**QUALITY ASSURANCE -- NON-CONFORMANCE REPORT**

**Location:** Changxing Island, Shanghai, P.R. China **Report No:** NCR-000604  
**Prime Contractor:** American Bridge/Fluor Enterprises, a JV **Date:** 05-Jan-2010  
**Submitting Contractor:** Zhenhua Port Machinery Company, Ltd (ZPMC), Changxing Island **NCR #:** ZPMC-0577

**Reference Description:** Excessive root gap at weld joint of FL3 to I- Rib Stiffener was welded with fillet weld in Segment 7DW

**Job Name:** SAS Superstructure

WI I DING MAI  
SSD 10A  
1/1

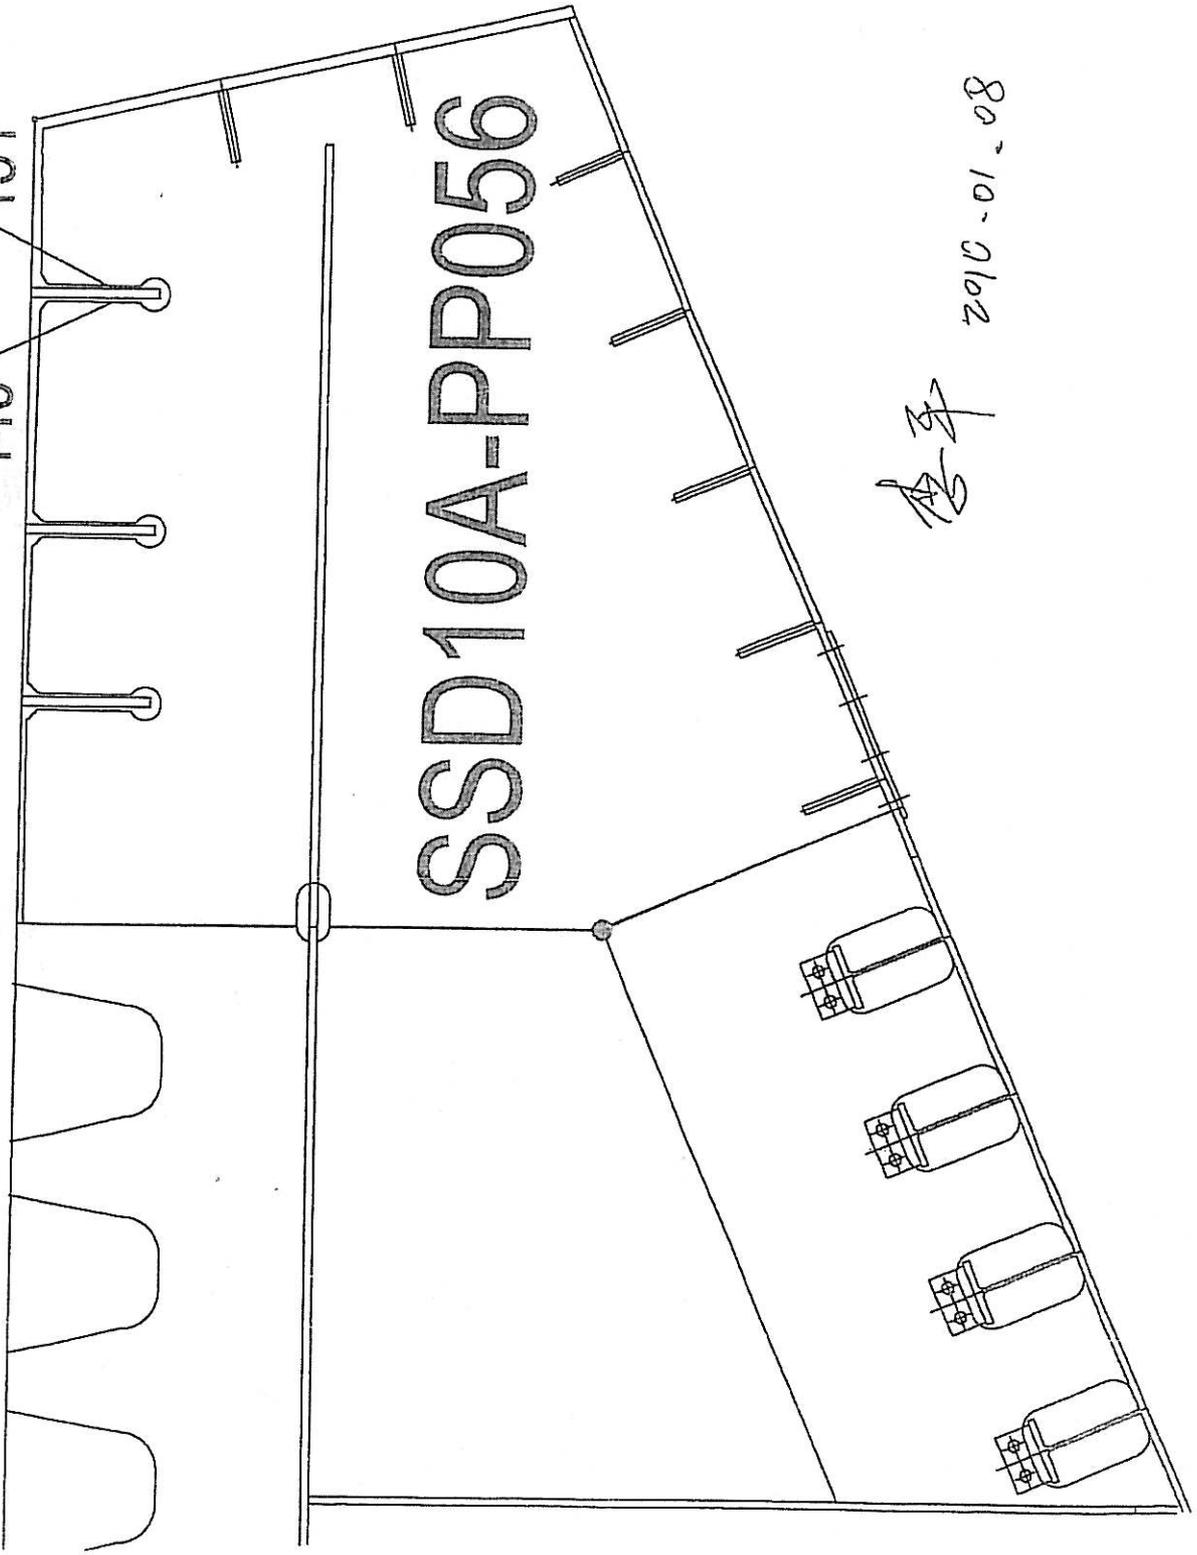
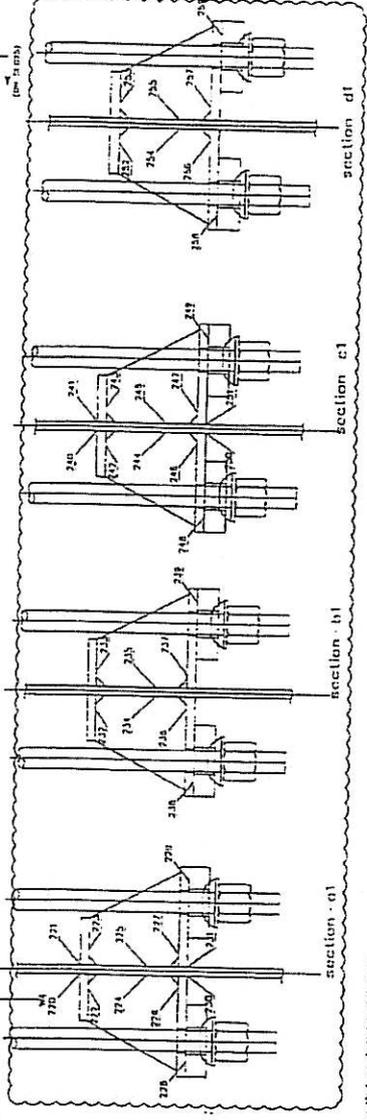
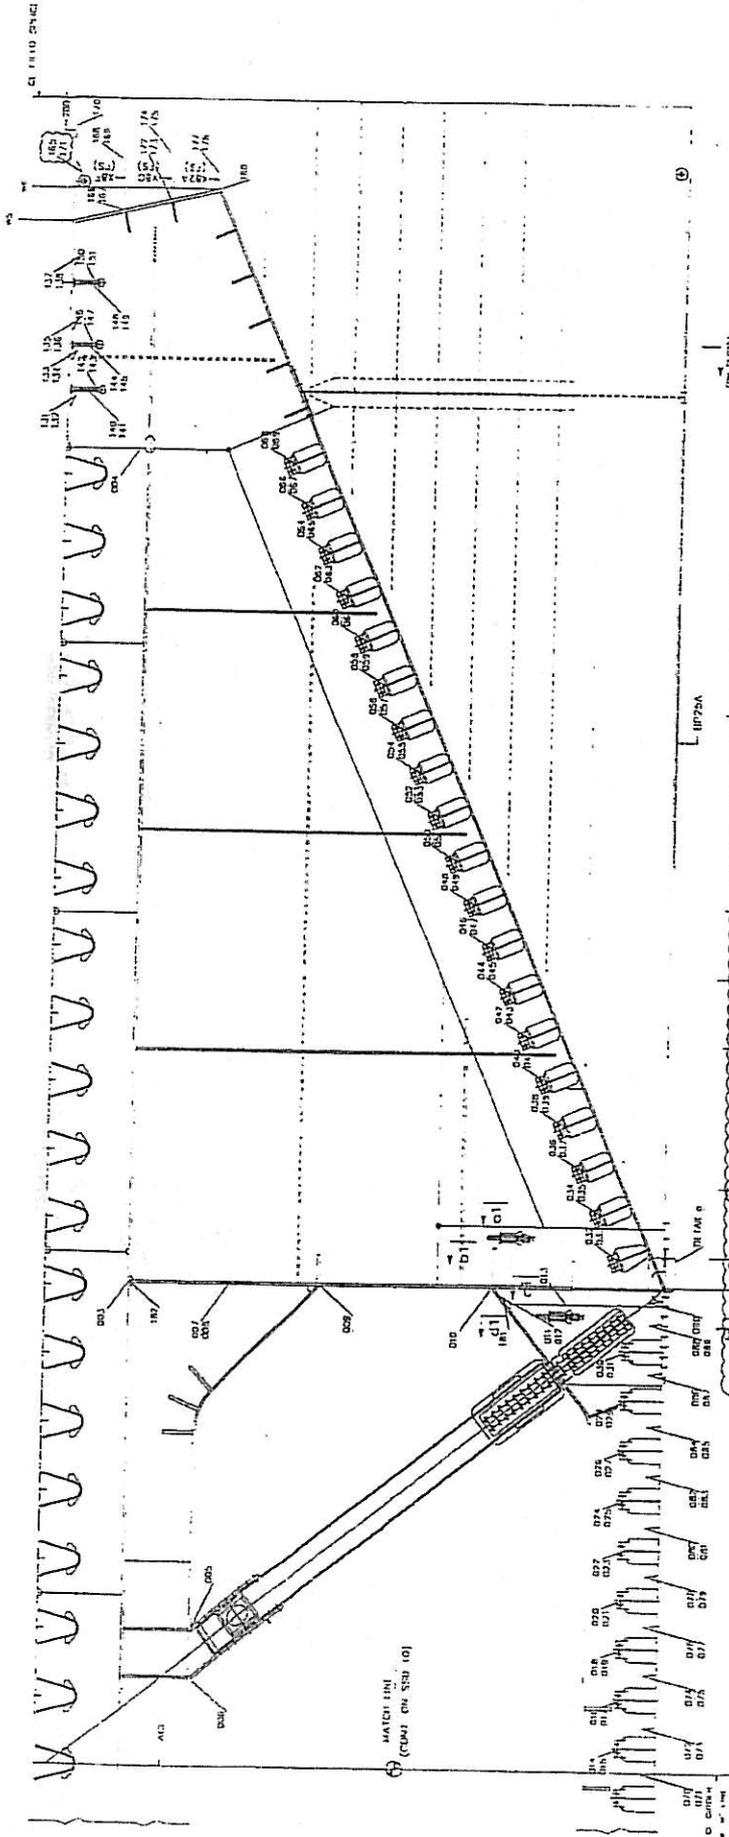
Out-of-tolerance Repair: Excessive Root Gap Turning Fillet Weld to CJP per Submittal 200R2

Lift/Segment: 70W Measured Gap Size (mm): Gap max = 7mm

Weld ID#: SS010A - PP56 - 148/149, 150/151

Engineer's Approval: <u>Yes</u> /No	Reviewed by: <u>ET</u>	Date: <u>12 JAN 10</u>	Time: <u>09:00</u>
Comments: <u>The work has already performed. This Notification does</u>

AGREEMENT: not serve its purpose in allowing CT to perform inspection prior to welding

gap=6mm  $\frac{148}{149}$   $\frac{150}{151}$  gap=7mm

- To incorporate the detail changes to the weld map.
- To reflect the changes in the shop drawings/as-built drawings.
- To reflect the changes on the QA Database. (i.e., CJP weld, intermittent weld length, UT inspection)
- To follow the repair method described in Sec. 6.2 of Submittal 200R2; RFCO 63.
- To provide inspection notification to CT for witnessing and inspecting the work indicated in the checklist below prior to starting.
